# Access Compliance Report

## Public Rights-of-Way

Intersection ID: 11979	Main Street: N_CALDWELL_ST	Cross Street: E_12TH_ST	Location: N
ADA ID: F21EB1A83D74	Ramp Type: Perp	Initial Pass/Fail: Fail	Overall Compliance: No
Severity Score: 13.75			
Codes/Mitigation Info/Possible Solution		Field Measurements/Component Compliance

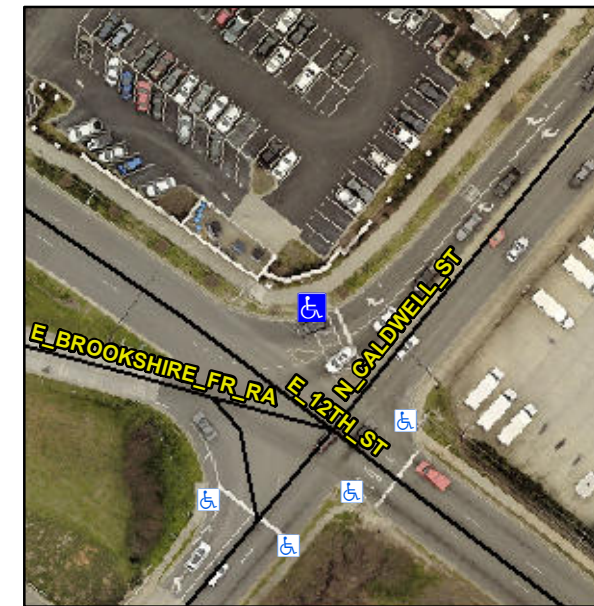
**Not Found, R304.2.2, R304.5.3**

Compliance	Description	Data	Compliance	Description	Data
N/A	Ramp Length (in)	84.5	No	Ramp Slope (%)	10.0
Yes	Ramp Width (in)	48.0	No	Ramp XSlope (%)	3.5
N/A	Flare Type LT	N/A	N/A	Flare Type RT	N/A
N/A	Flare Slope LT (%)	N/A	N/A	Flare Slope RT (%)	N/A
N/A	Flare Traversable LT?	N/A	N/A	Flare Traversable RT?	N/A
N/A	Landing Length (in)	N/A	N/A	DWS Provided?	N/A
N/A	Landing Width (in)	N/A	N/A	DWS Contrast?	N/A
N/A	Landing Slope (%)	N/A	N/A	DWS Length (in)	N/A
N/A	Landing X Slope (%)	N/A	N/A	DWS Full Width?	N/A
N/A	Landing Curb? (Y/N)	N/A	N/A	DWS Offset (in)	N/A
N/A	Shared Landing?	N/A			
N/A	Gutter Ponding?	N/A	N/A	Gutter Slope (%)	N/A
N/A	Gutter Lip Ht (in)	N/A	N/A	Gutter X Slope (%)	N/A
N/A	Painted X Walk1?	Yes	N/A	Painted X Walk2?	N/A
	X Walk 1 Direction	To SE		X Walk 2 Direction	N/A
N/A	X Walk 1 Width (in)	113.0	N/A	X Walk 2 Width (in)	N/A
	X Walk 1 Slope (%)	2.0		X Walk 2 Slope (%)	N/A
	X Walk 1 X Slope (%)	2.4		X Walk 2 X Slope (%)	N/A

**Remove & Replace Entire Ramp.**
